CMB Meeting Minutes #163

REFERENCE Project No. M544.1, Contract No. 149 Task 1-8.02

SUBJECT: Configuration Management Board Meeting # 163 – Rev. No. 0

CONTRACT NO. 1252
DRAWING NO. RP-150
FILE NO. 91,680
REV. NO. 0

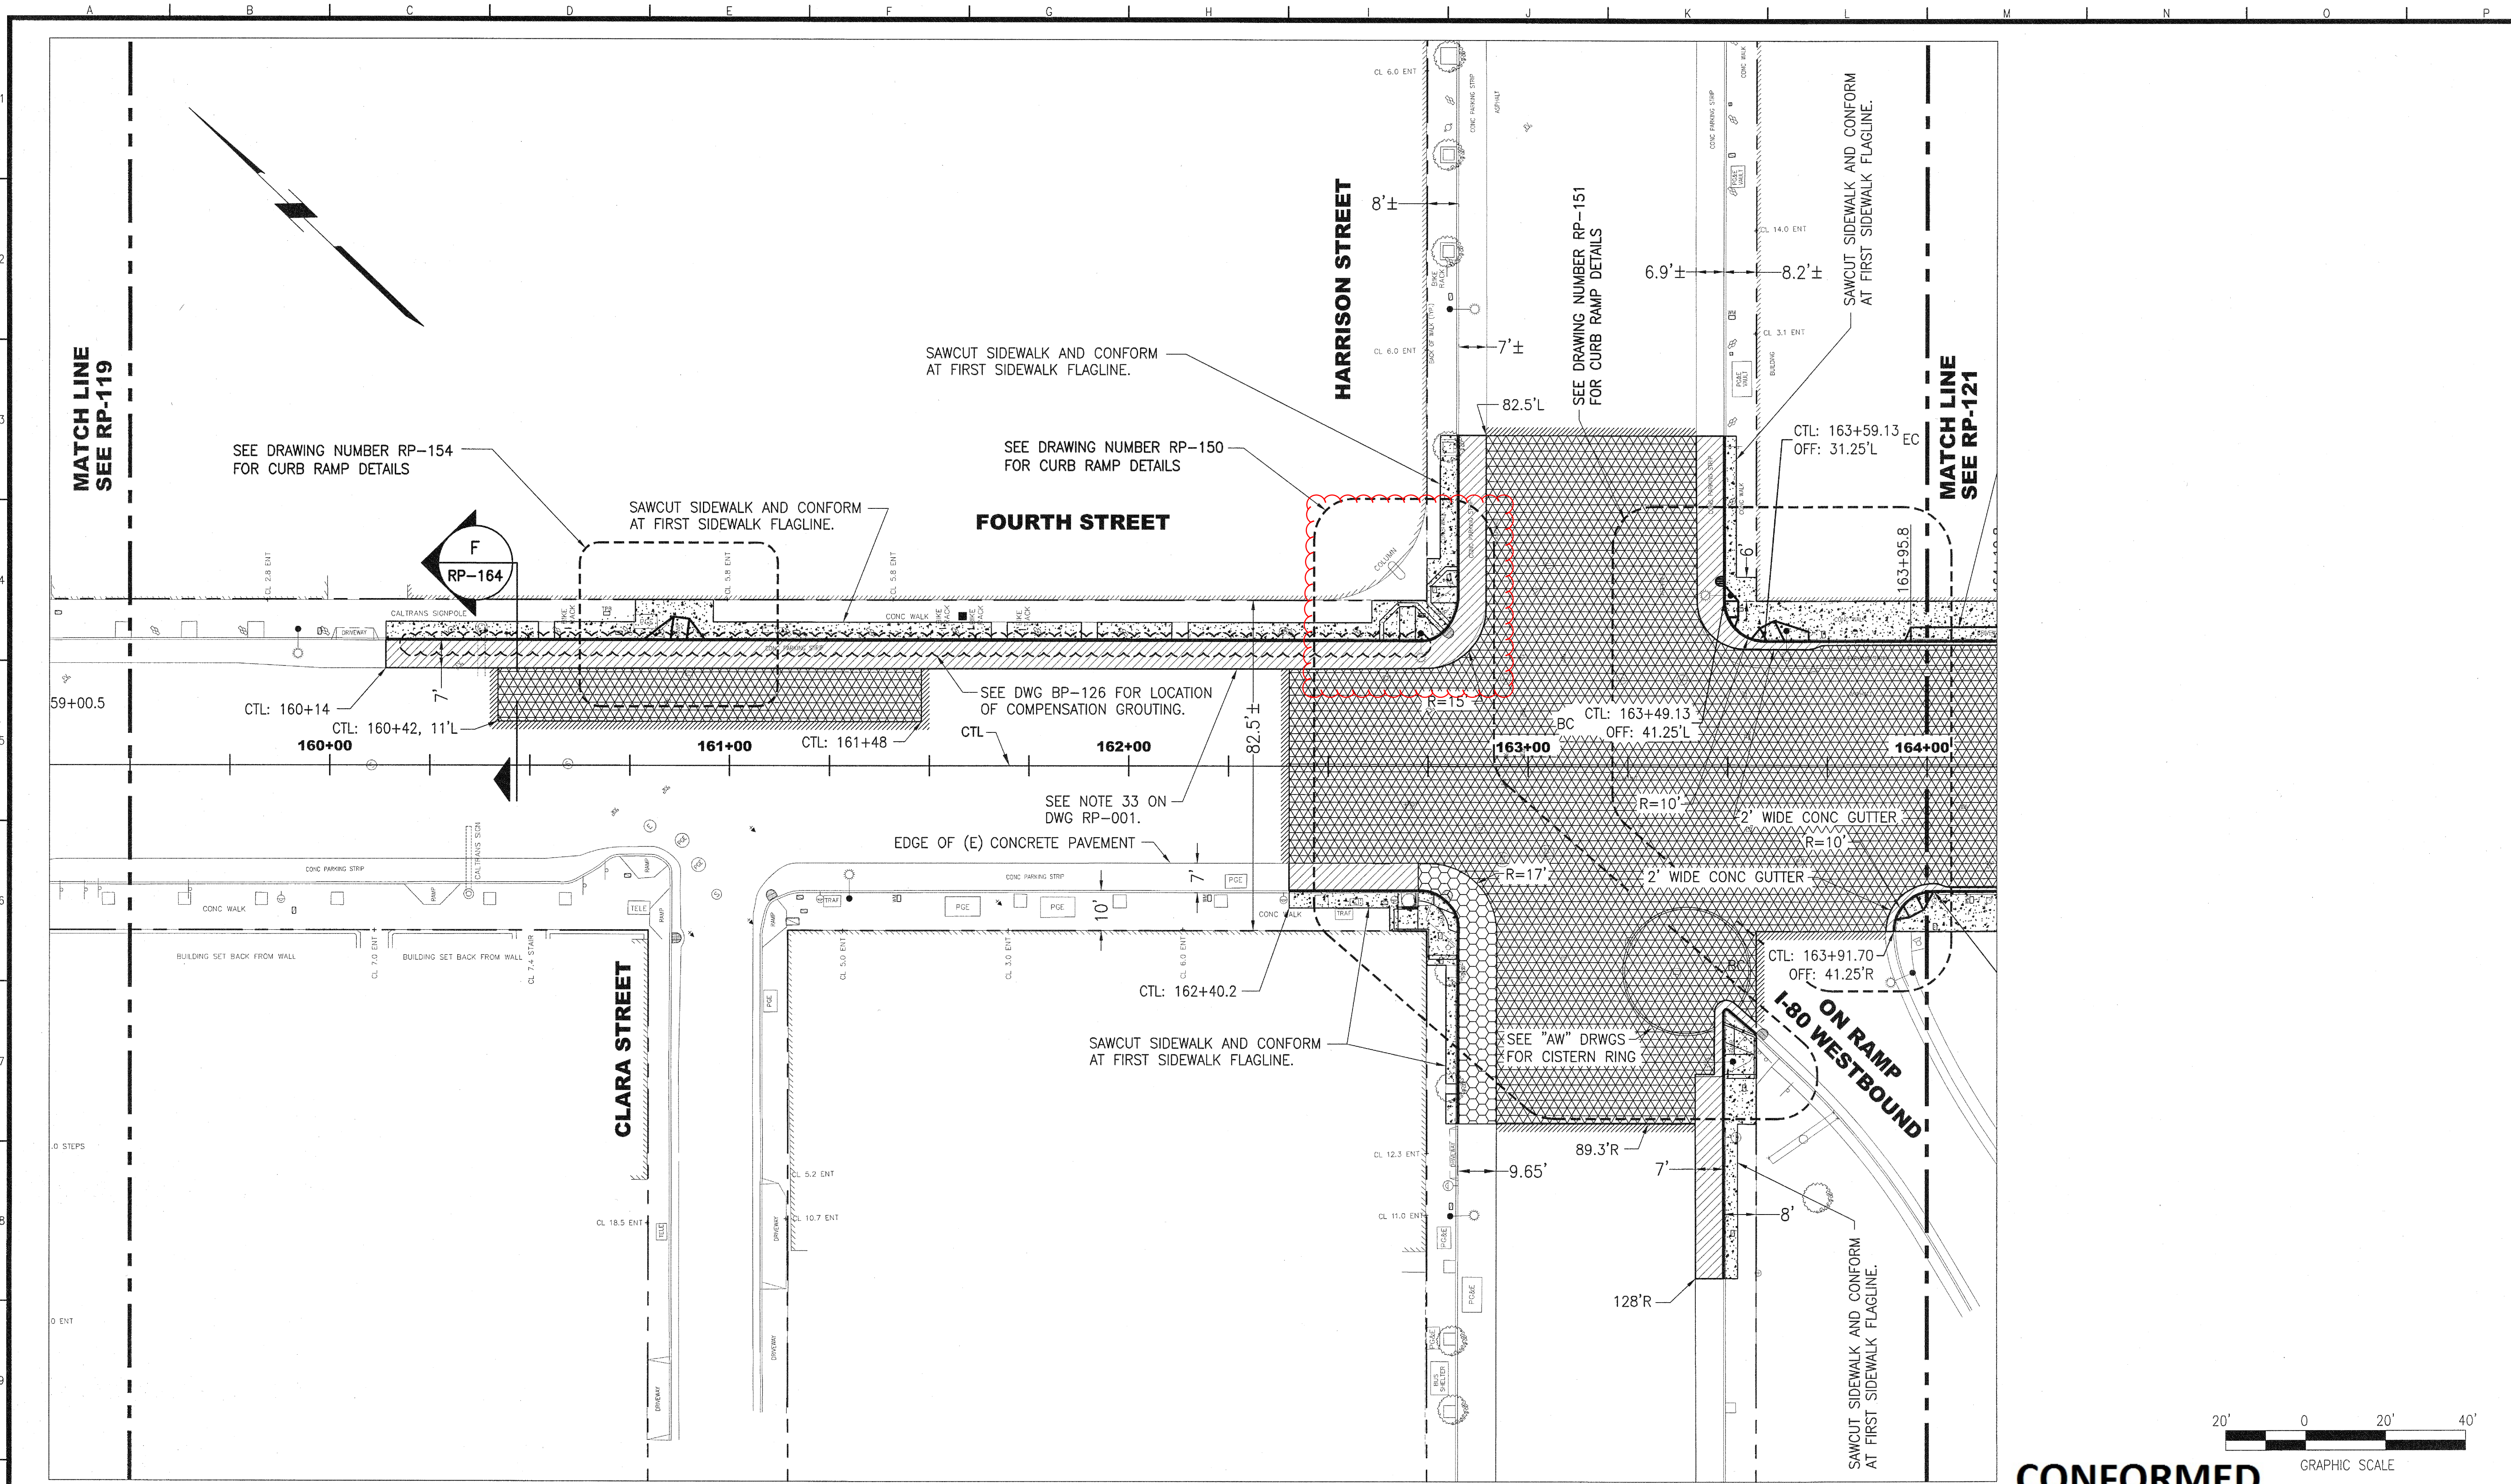
Existing cast-in-place PG&E pull box discovered in footprint of curb ramp to be installed per base Contract. Presence of pull box prevents installation of curb ramp according to Contract plans. Pull box not shown in Contract documents.

The conflicting ramp (Harrison Street side) will be shifted west to avoid conflict with the existing pull box. This shift will require the 4th Street ramp to be reduced in length. Five (5) flags of existing flat sidewalk (originally to remain per base Contract) will be replaced with sloped concrete in order to reach the revised ramp while not exceeding the maximum allowable slope for sidewalks/ramps.

Project: Central Subway Stations, Surface Track & Systems
Subject: FH conflict at Washington e/o Stockton, Sta. 11+76
Requested By: Marcus Gomez
Specs/Drwg Reference: AWSS 201.6
Date Reply Requested: ASAP

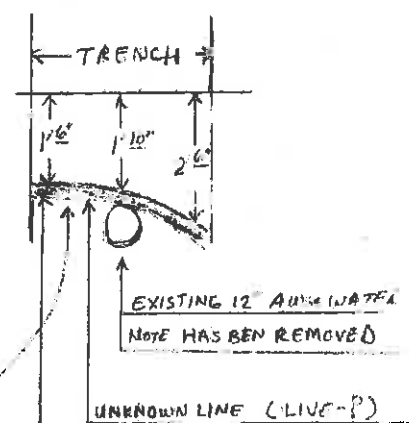
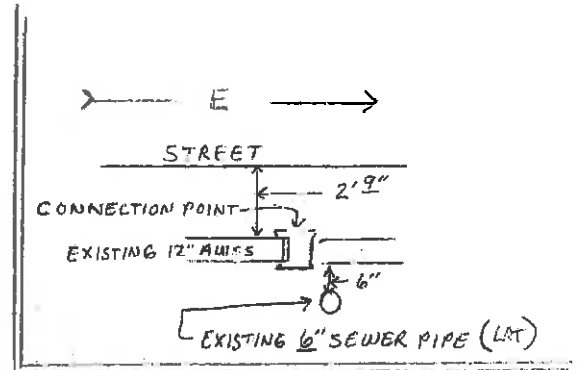
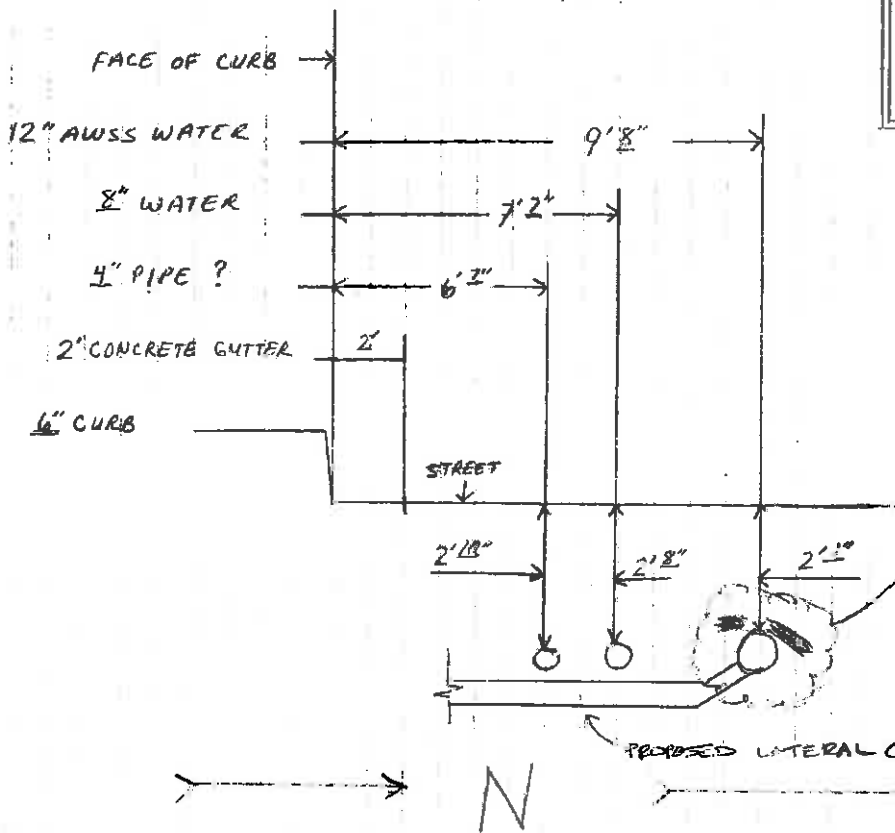
Per FACO 10 and RFI 160.1, the revised hydrant lateral was excavated and the proposed lateral was confirmed to be in conflict with an existing 4" & 8" utility. At the proposed tee location, an existing 3" steel line was found in conflict with the proposed top of tee.

Please provide direction on how to temporarily move the steel line and how to configure the proposed tee and hydrant lateral assembly. Please keep in mind the lead times for any additional AWSS material not shown on the contract drawings.

Attached is a sketch and photos of the existing conditions.
